Berkeley Springs Bath House  
Addendum Bulletin No. 2

**DEPT. of Natural Resources**  
**Additions and Alterations to**  
**Berkeley Springs Bath House**  
**RE-BID**

**AAI PROJECT NO.: 0408097.00**  
**DNR-80062**  
January 8, 2007

| REV. BY:<br>BCM   | DWG. DESCRIPTION:<br>NEW ELECTRICAL RISER<br>DIAGRAM - PART A | DWG. NO:<br>AD-001 1 OF 3 |

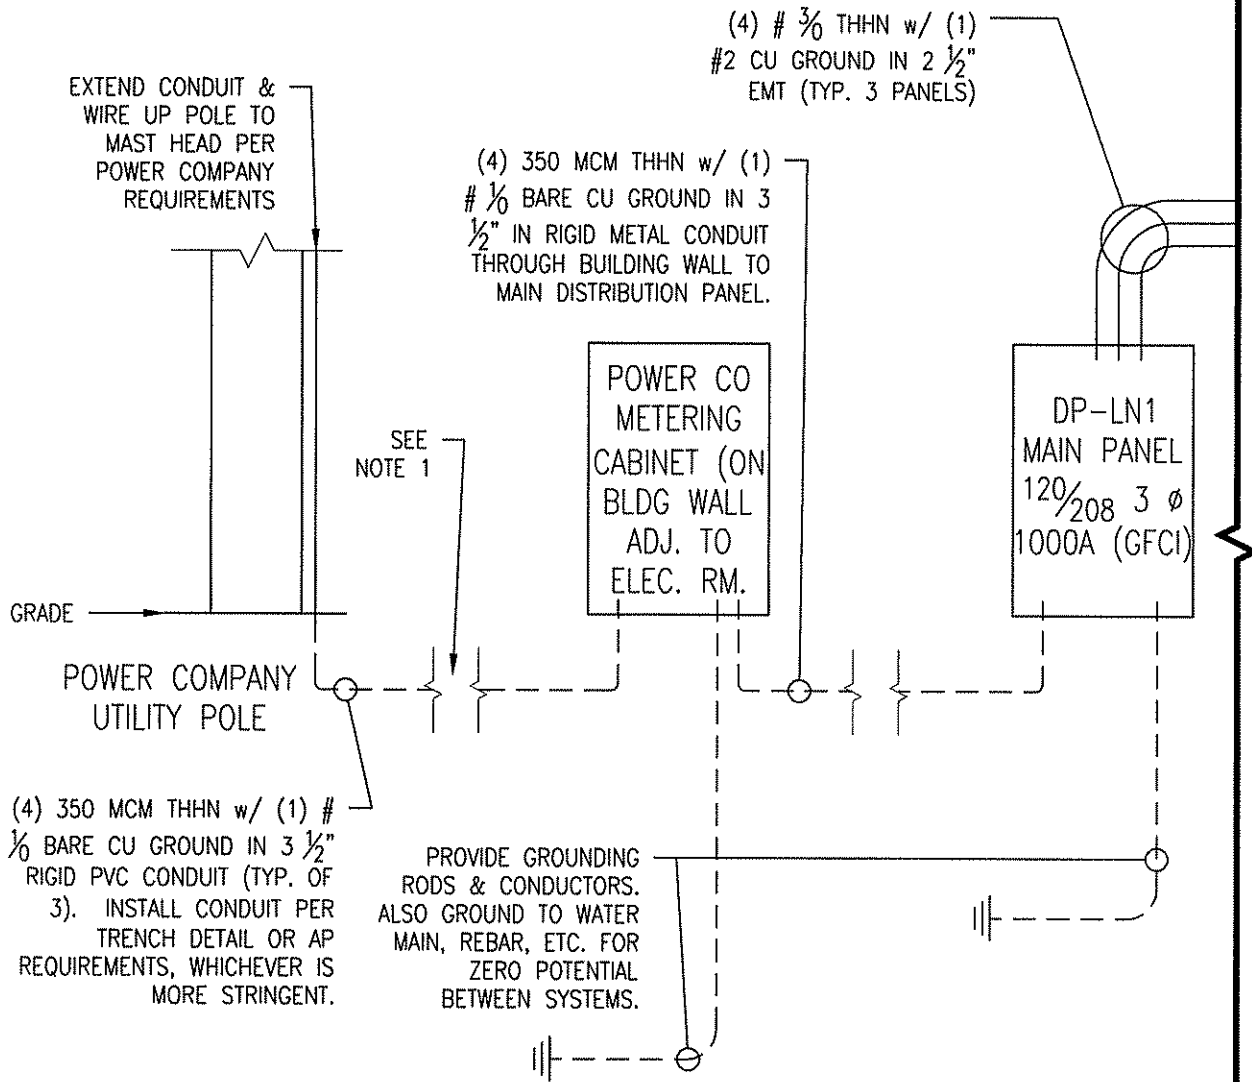
17. Please Provide a Power riser or Single Line Diagram to confirm (1) conduit feeder wiring requirements from Main Panel to subpanels and existing loads and (2) electrical details and design for the Incoming Electrical Service.

**General Notes and Comments:**

Verify the incoming available fault current with Allegheny Power and review with the Engineer prior to submitting and purchasing electrical panels.

Provide 3" conduit from phone company pole or post to the point of service inside the building.

Provide an incandescent wet location "jelly jar" light fixture, switch, and 20 A GFCI receptacle exterior mounted to each rooftop AHU. Work includes conduit penetrations of roof.

- a. Answer: See attached for riser diagram for new panels. For the purposes of bidding, assume the metering is pole mounted by the power company. The existing load ampacities for reconnection are on the panel schedule. Use NEC to determine reconnection feeder and conduit sizes by ampacities listed.

| REV. BY:<br>BCM   | DWG. DESCRIPTION:<br>NEW ELECTRICAL CONDUIT<br>TRENCH DETAIL | DWG. NO:<br>AD-001 3 OF 3 |

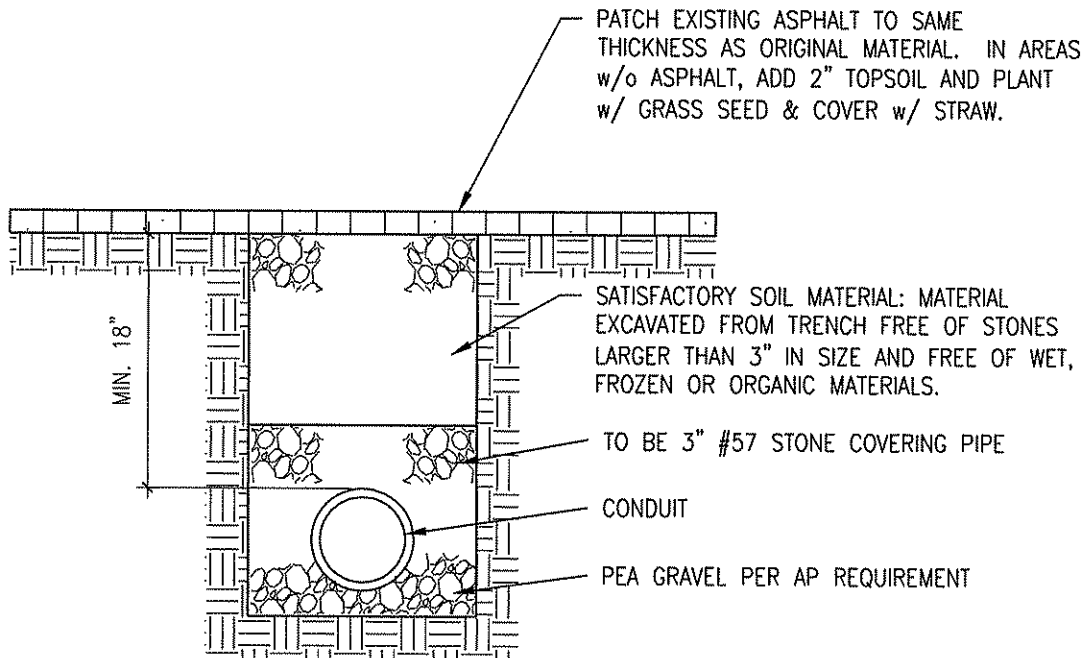
20. Provide a copy of the trench detail indicate for power and control underground conduits to the exterior chiller noted on drawing E-1.1
- a. Answer: Yes
